Southern California Edison Company

Subject: Docket No. 50-206, Amendment Application No. 211, Supplement 1, Fuel Storage Facility Thermal and Structural Analyses, Permanently Defueled Technical Specifications, San Onofre Nuclear Generating Station, Unit 1

FINAL ANALYTICAL RESULTS

FIGURES 1, 2, AND 3 OF AMENDMENT APPLICATION NO. 211

Figure 1. Spent Fuel Pool Heat Load During Permanently Defueled Condition

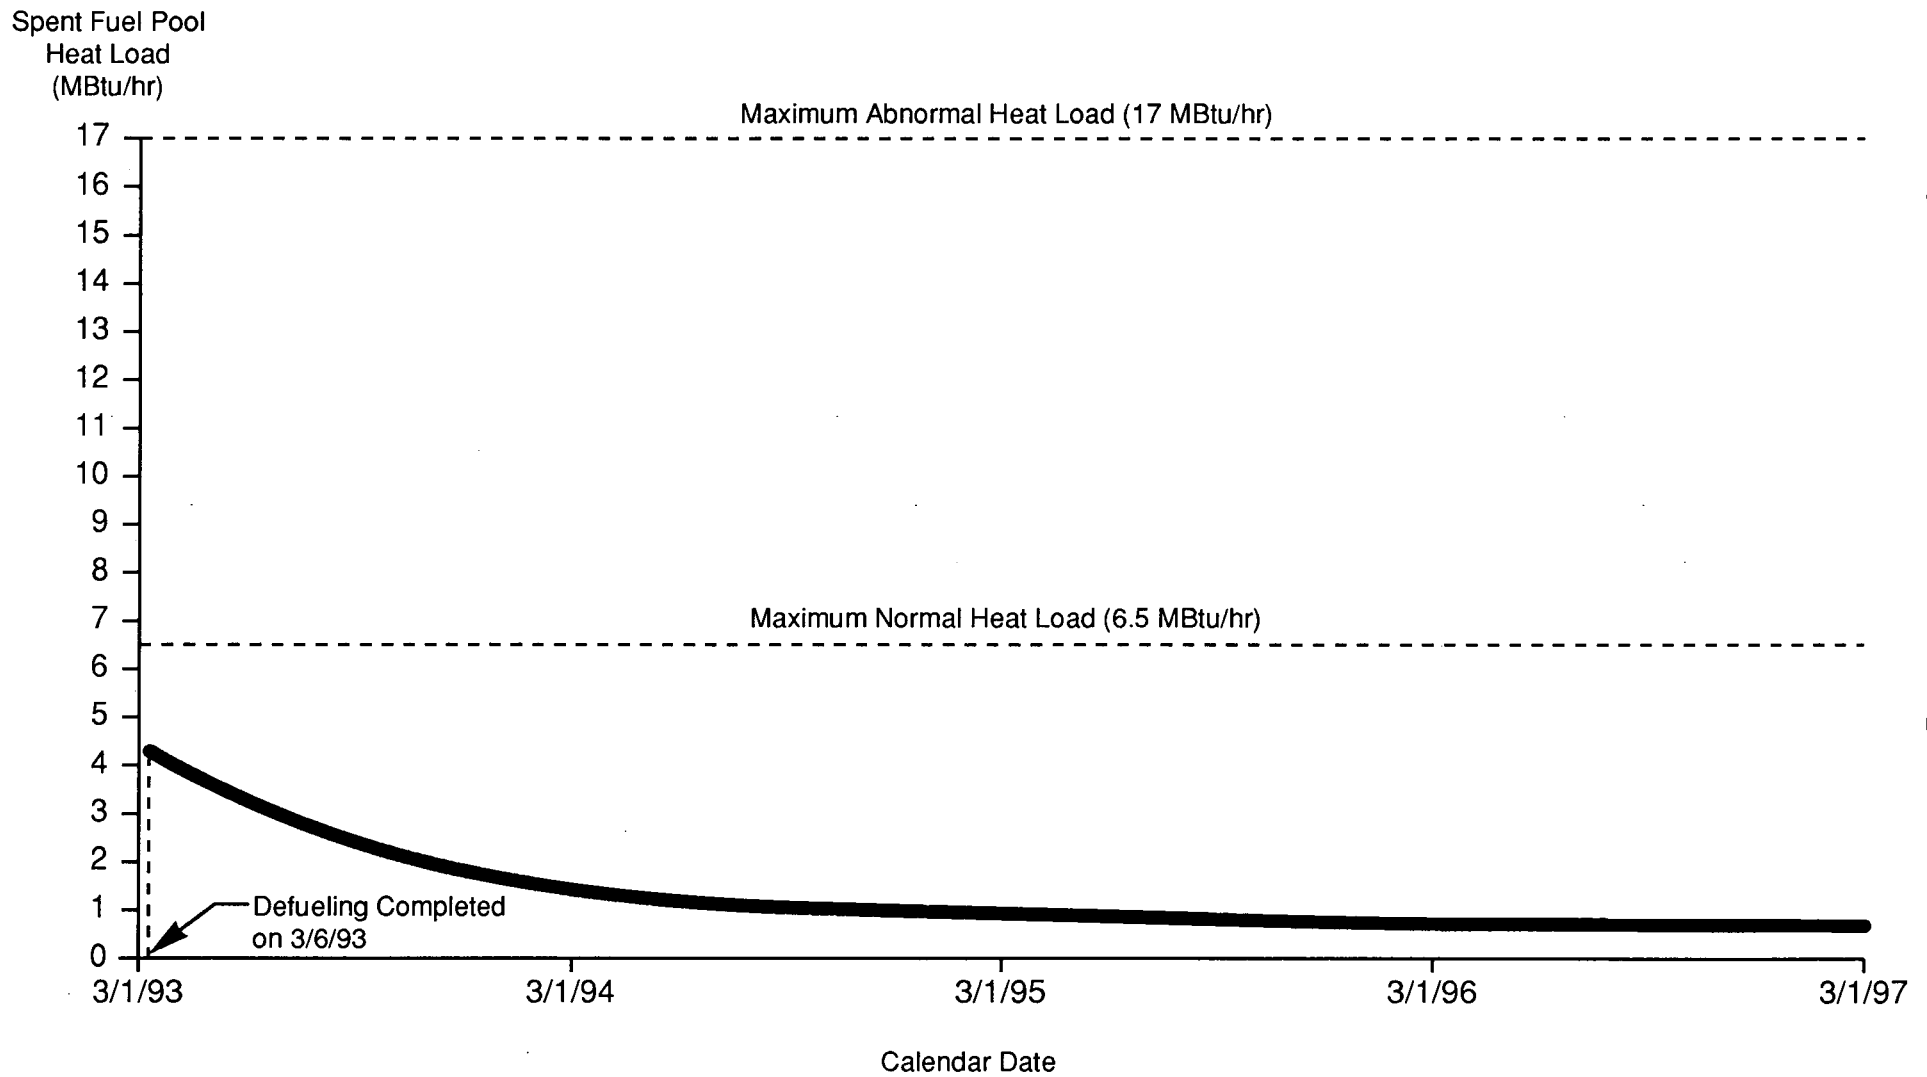
Most of the final results of the thermal analysis are identical to the corresponding preliminary results submitted earlier. Specifically, the SFP heat load (Figure 1) and time to heat up to 150°F (Figure 2) results are unchanged. Therefore, by August 1, 1993, the SFP heat load will be less than

Final versions of Figures 1, 2, and 3 in the amendment application are included in Enclosure 1 to support the Commission's review of the proposed PDTS. Each figure is noted as being final rather than preliminary. Additionally, the calendar date axis in Figure 1 has been rescaled slightly to correct a plotting discrepancy that was contained in the preliminary version of that figure.

Figure 3. Spent Fuel Pool Equilibrium Temperature and Maximum Evaporation Rate With No Cooling in Operation (open fuel storage building rollup and personnel access doors)

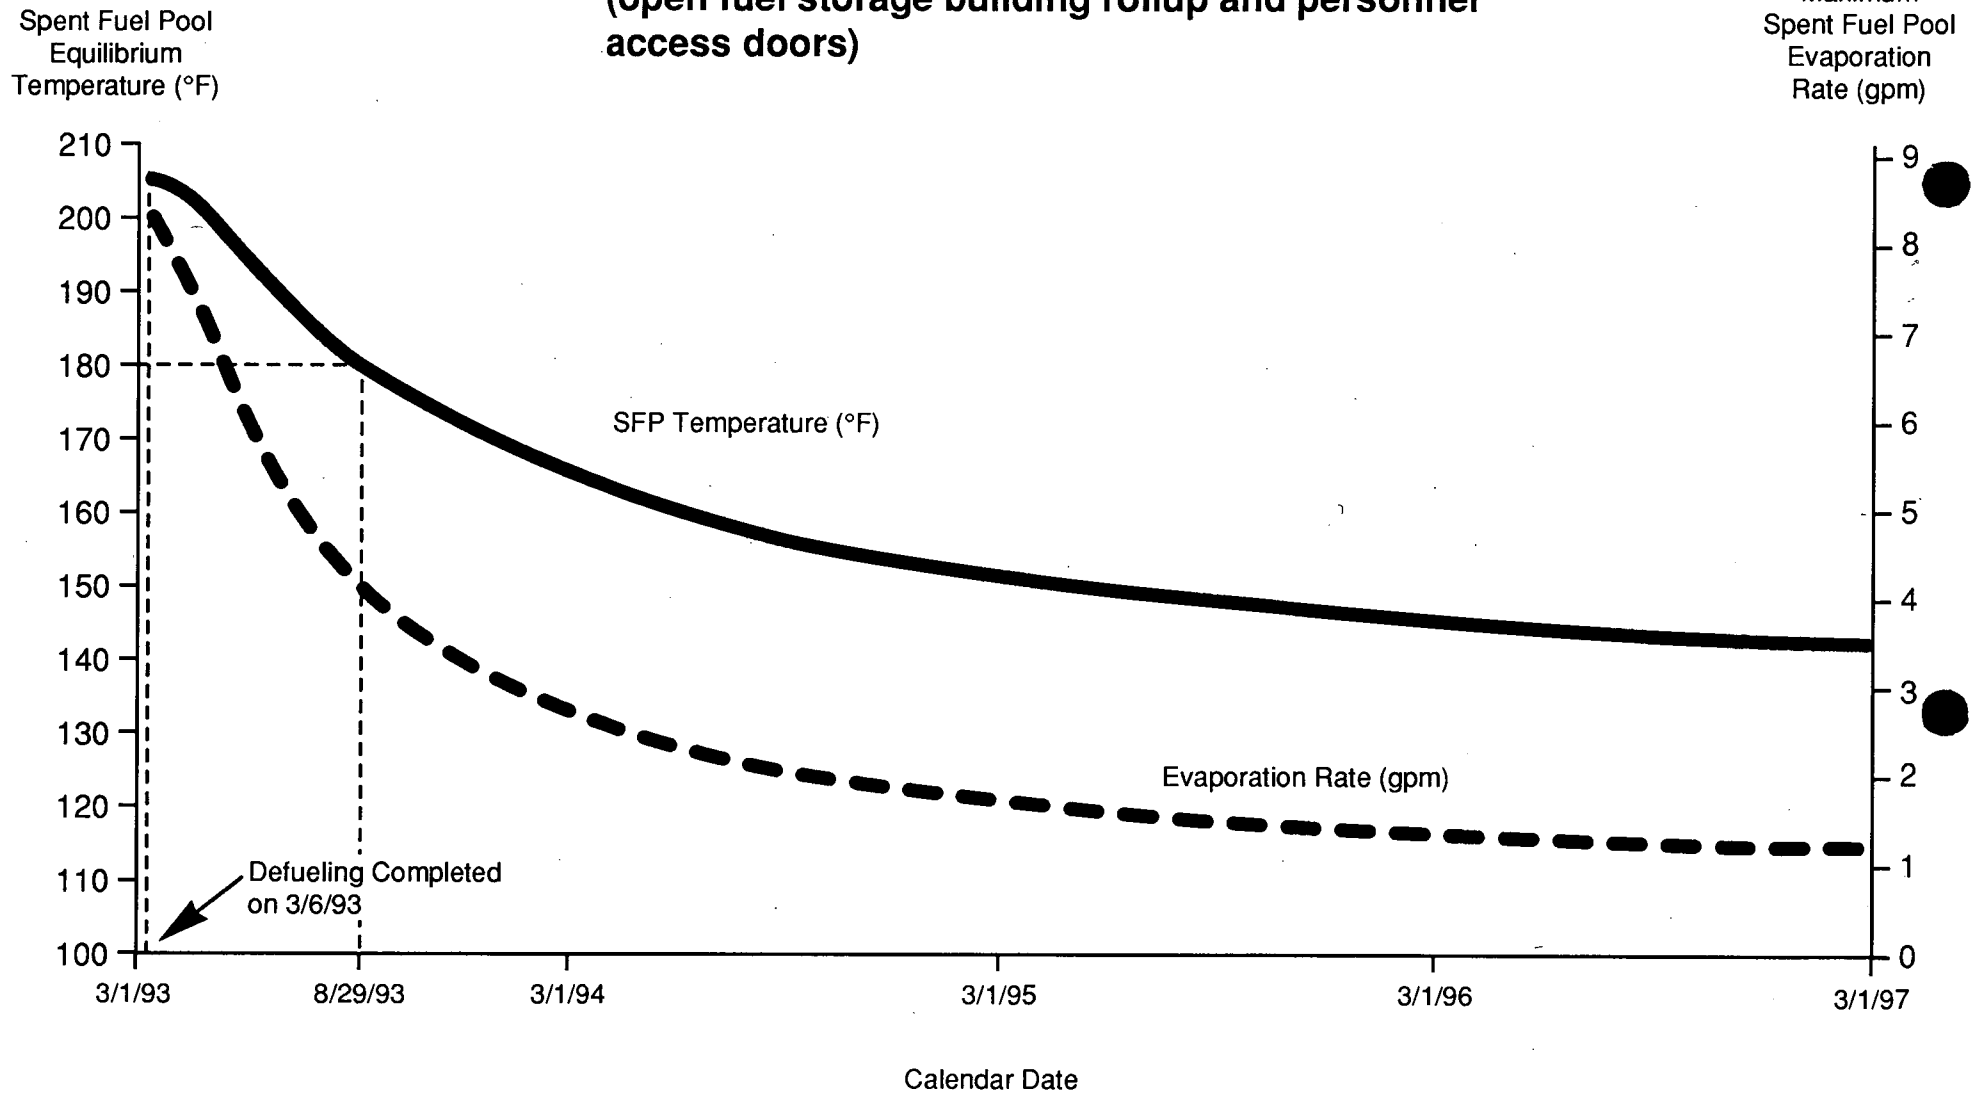
However, the final results for SFP equilibrium temperature and maximum evaporation rate during loss of cooling conditions differ slightly from the preliminary results included in Figure 3 of the amendment application. For example, the timing for an SFP equilibrium temperature of 180°F is projected for August 29, 1993, rather than the preliminary date of August 26, 1993. Additionally, the SFP maximum evaporation rate that could occur if forced cooling were lost after August 29, 1993, is 4.1 gpm rather than 4.5 gpm. The slight changes in the calculated parameters of Figure 3 are not significant. The conclusions of the PDTS significant hazards consideration analysis concerning the adequacy of SFP makeup water sources and the capability to passively cool the SFP are confirmed by the final analytical results.

The slight reduction in the calculated SFP maximum evaporation rate during loss of forced cooling conditions means the predicted rate for lowering of the SFP water level is less than previously indicated in Amendment Application No. 211. For example, the time stated in the Basis of proposed PDTS D3.2 for the SFP water level to drop within 10 feet of the stored fuel, assuming makeup remained unavailable, is conservatively calculated to be 24 days rather than 22 days. This result also supports the conclusions of the PDTS significant hazards analysis.
